**City of Suffolk  
HISTORIC LANDMARKS COMMISSION**

**January 9, 2020**

Subject: **REQUEST FOR CERTIFICATE OF APPROPRIATENESS HLC2018-00026**, submitted by Jean Claude Noel, applicant and property owner, for after-the-fact installation of fencing at property located at 237 Pinner Street. The property is further identified as Zoning Map 34G18, Block A, Parcel 153, Suffolk Voting Borough, zoned RM, Residential Medium zoning district, and HC, Historic Conservation Overlay District.

Subject: **REQUEST FOR CERTIFICATE OF APPROPRIATENESS HLC2019-00038**, submitted by Ben Clay, applicant and property owner, for exterior material alterations and window replacement on property located at 130 Brewer Avenue. The affected area is further identified as Zoning Map 34G17, Block 2 B, Parcels 18, 19, and 20, Suffolk Voting Borough, zoned CBD, Central Business District, and HC, Historic Conservation Overlay District.

PHYSICAL SURVEY  
 OF  
 PROPERTY LOCATED AT  
 #237 PINNER STREET  
 (REF: DEED BOOK 51, PAGE 199)  
 SUFFOLK, VIRGINIA  
 FOR  
**JEAN-CLAUDE NOEL &  
 MARIE L. NOEL**  
 SCALE: 1" = 60'

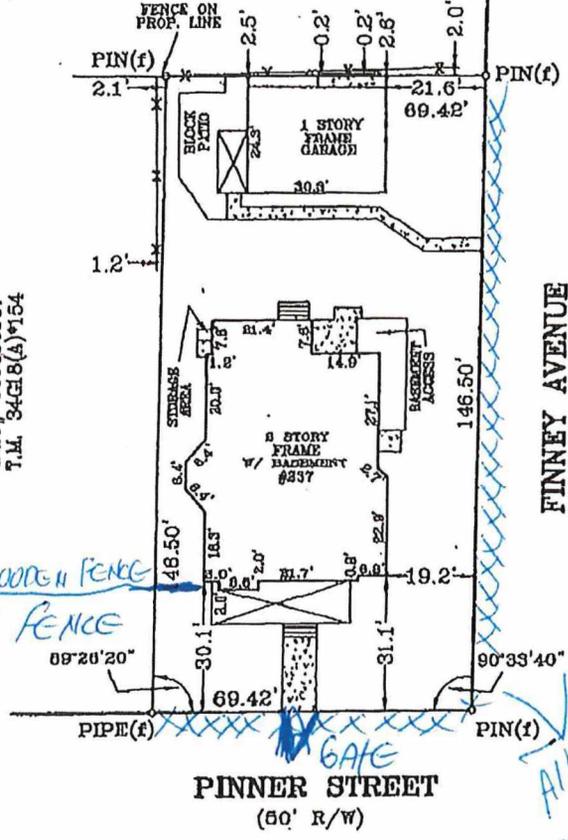
The subject property fronts on both Pinner Street and Finney Avenue and currently has a 6 foot tall wooden fence that was installed adjacent to the front corner of the house and extended to the southern property line. The applicant is requesting after-the-fact approval of the 6-foot tall privacy fence and is proposing to paint the fence with the color white. In addition, the applicant is requesting to install a 4-foot tall black aluminum fence and walkway gate across the eastern property line, extending across the northern property line.

The requested 6-foot tall wooden fence is inconsistent with the existing fencing along the rest of Pinner Street, which includes various low brick walls, wood picket, and black aluminum fencing. The existing fence is typical of residential privacy fencing and is attached at the front corner of the house approximately 25 feet from the sidewalk. This location is highly visible from Pinner Street and is not screened. As stated in the Guidelines, privacy fencing may be appropriate in the rear or side yard where it is not visible from a public way. The existing location of the privacy fence is not appropriate for a 6-foot tall wooden fence due to the high visibility from Pinner Street. Staff recommends that the privacy fence be moved to the rear corner of the home to extend across to the southern property line. This location is set back further from Pinner Street and would offer the opportunity to screen it from the street with bushes like those found elsewhere on the street. This would result in less visible impact from the street and to the Historic District. The applicant is also proposing to paint the fence utilizing the color white. The painting of the fence is an appropriate treatment of wood fencing within the Historic District and is consistent with fencing elsewhere on the street.

In addition, the applicant is proposing to install a black aluminum fence and walkway gate that will extend along the existing sidewalk bordering the eastern and northern property lines. The subject property has two front yards since it fronts on both Pinner Street and Finney Avenue. The proposed location of the fencing is highly visible from both streets. Decorative fences are usually used where fences will be visible from public streets in front and side yards to accent the yard and provide some degree of enclosure. No fence located in any required yard adjacent to a street which creates a solid screen may exceed 30-inches in height. If such fence is uniformly 50% or more opened, it may be erected to a maximum height of 48-inches. The proposed aluminum fencing is to be no more than 4 feet in height and at least 50% open. The requested black aluminum fencing is consistent with the existing front yard fencing along Pinner Street and is the appropriate type of fencing for front yards meeting the height requirements. As such, the requested location and type of fencing would be appropriate to the Historic District. Additionally, this type of fencing is consistent with other fencing throughout the District.

1. Install a 4' tall black aluminum fence along the eastern and northern property lines adjacent to the existing sidewalks.
2. Install one matching black aluminum gate across the front walkway.
3. All aluminum fencing shall be 50% open.
4. Install one section of wood paneled fence, 6' in height, to extend from the rear corner of the house to the southern property line. The fence shall be painted white.
5. Install screen landscaping in front of the section of wood paneled fence to be approved by the Director of Planning and Community Development.
6. Any additional improvements shall require a separate Certificate of Appropriateness.
7. All required building and zoning permits shall be obtained from the City of Suffolk.

130 Brewer Ave, Suffolk, VA  
RIGHT

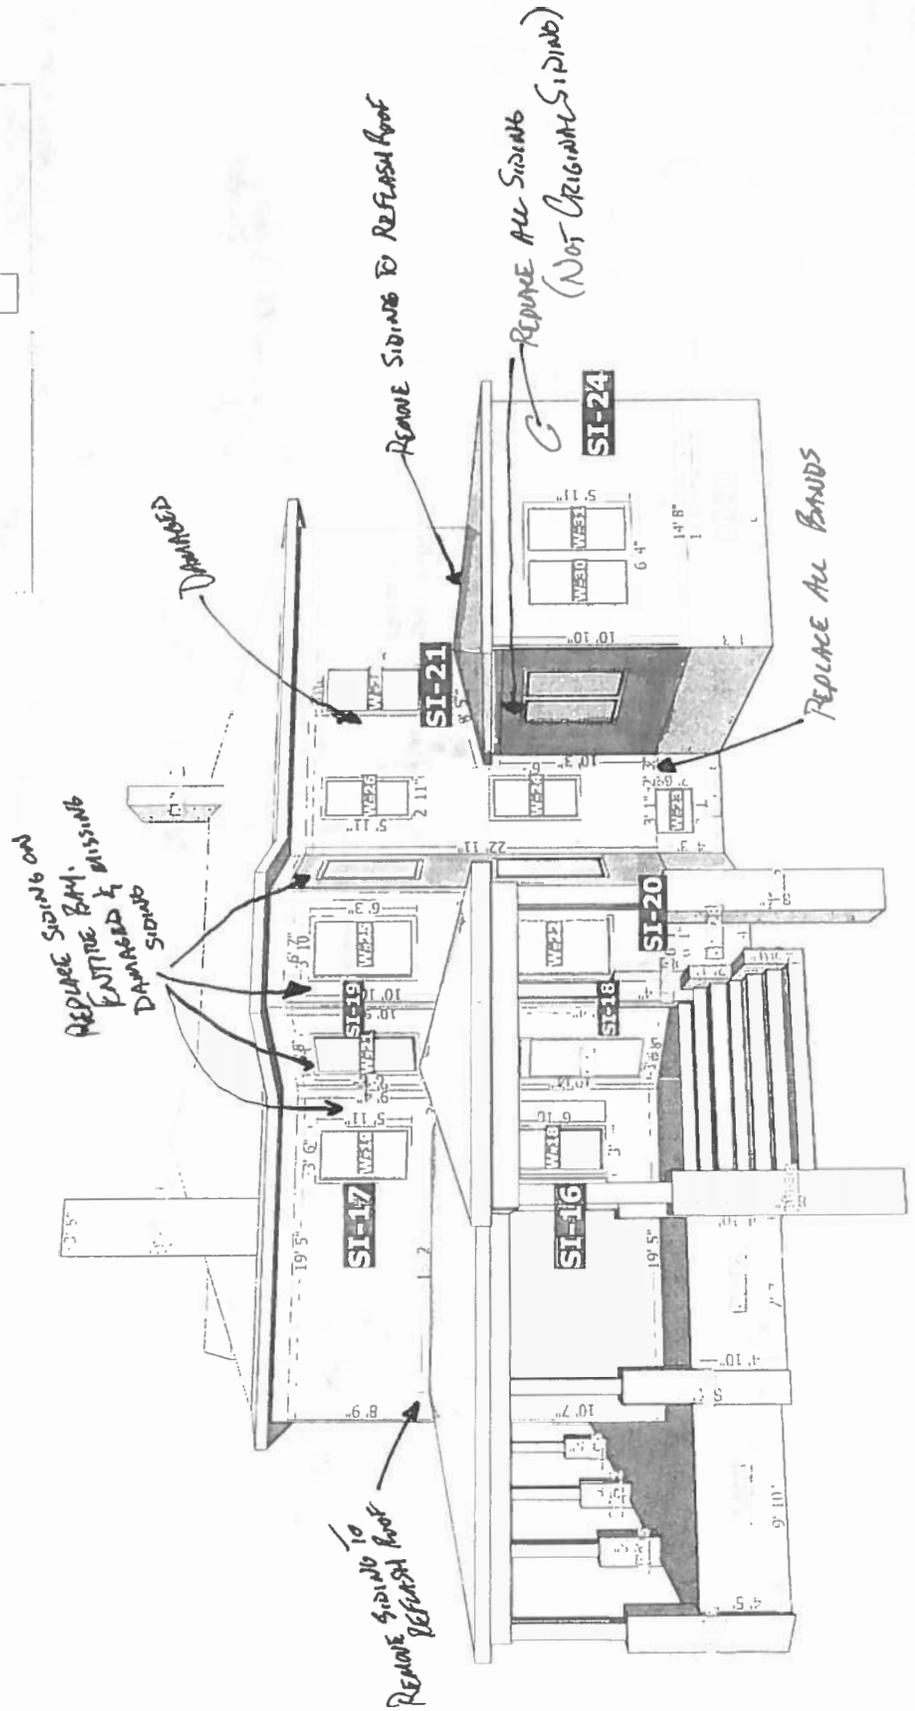
- Entire bay needs replaced; cracked boards and missing siding
- Replace all siding on "addition"; has non-matching siding
- Remove siding above addition roof to reflash
- Replace siding on entire band
- Behind all existing shutters damaged

RIGHT SIDE:  
Approx. 73% REPAIRMENT

130 Brewer Ave, Suffolk, VA  
BACK

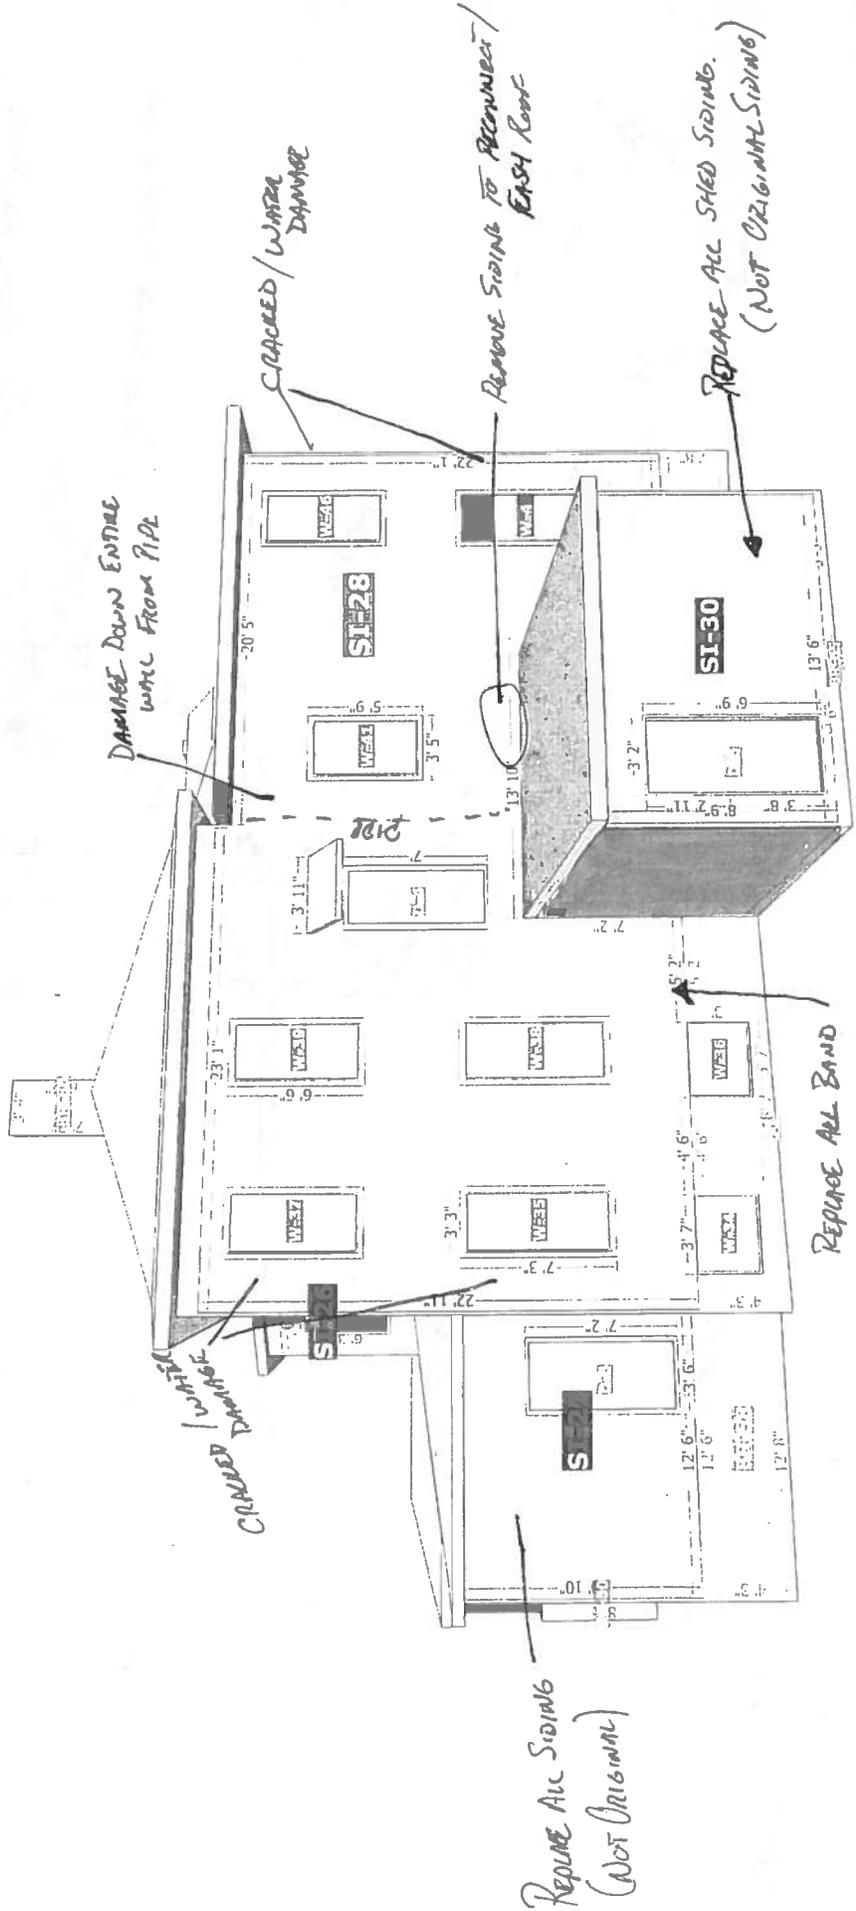
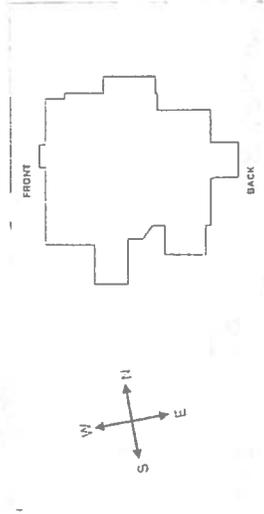
- Replace all siding on "shed"; has non-matching siding
- Replace siding above shed; non-matching siding
- Outer edges of two story walls damaged all the way up
- Full wall damaged behind pipe
- Replace siding on entire band
- Behind all existing shutters damaged

REAR:  
APPROX. 76% REPAIRMENT

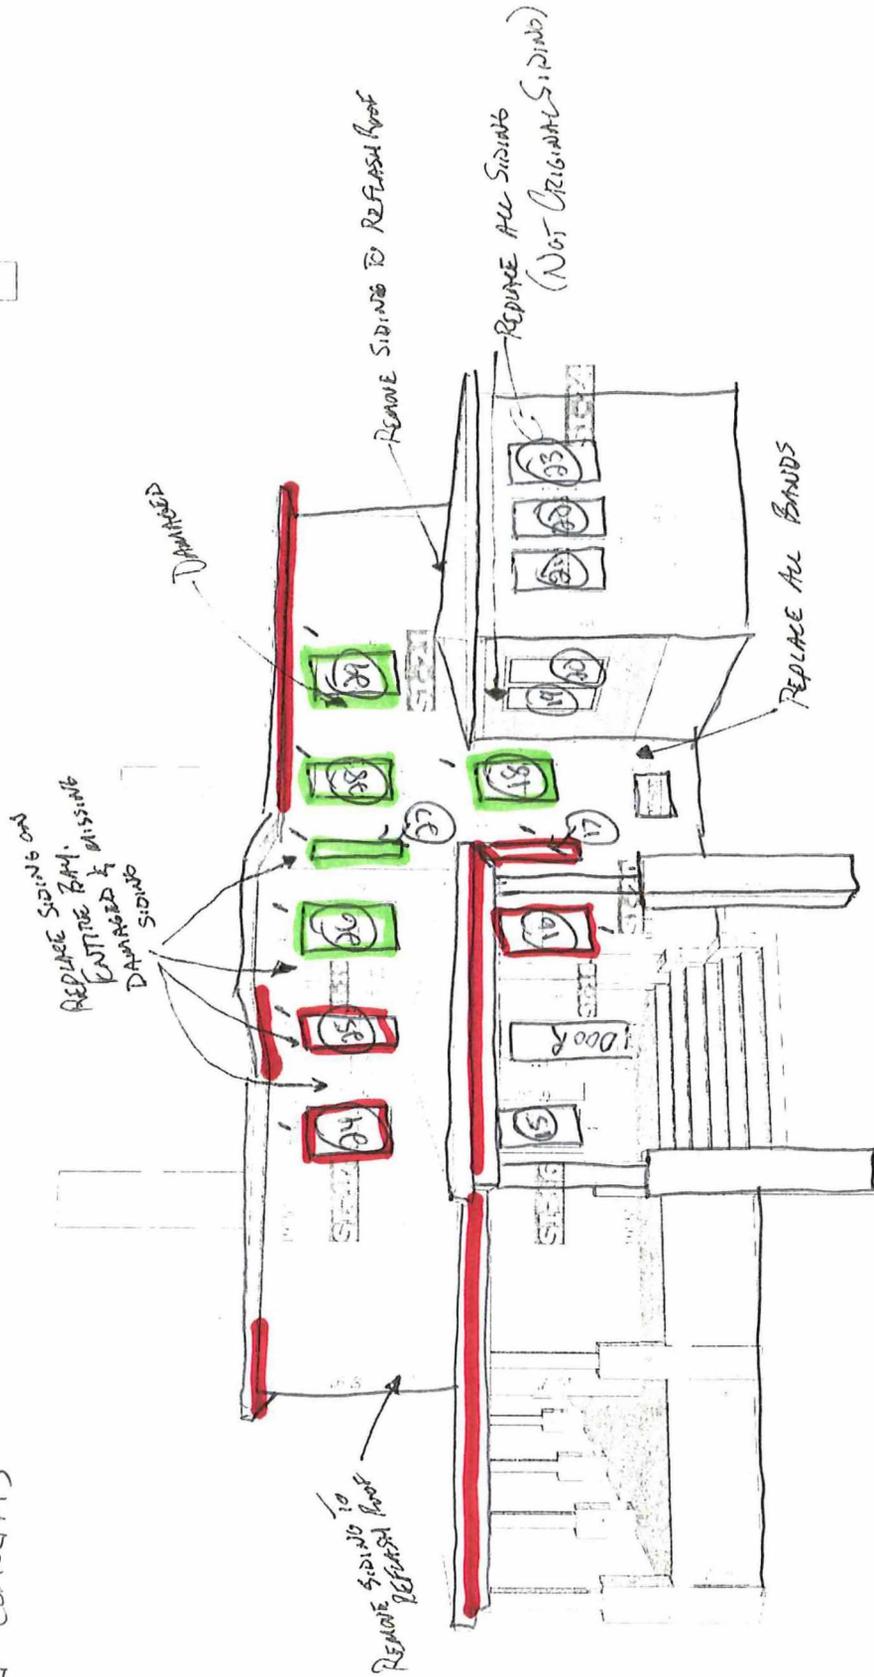
Right side of house – approximately 78% of the molding is rotten, falling off, or is missing

Rear side of house - Approximately 70% of the molding is rotten, falling off, or missing.

Left side of the house – approximately 75% of the molding is rotten, falling off, or missing.

The replacement material will be a Hardi molding and dental block that will match the existing height and width of each part. The molding will have to be removed in order to install the water vapor barrier when installing the new siding. Since there is so much of the dental molding and block that is rotten or missing, that would lead us to believe that when we remove what is on the home currently, it will not be able to be removed and salvaged due to rot
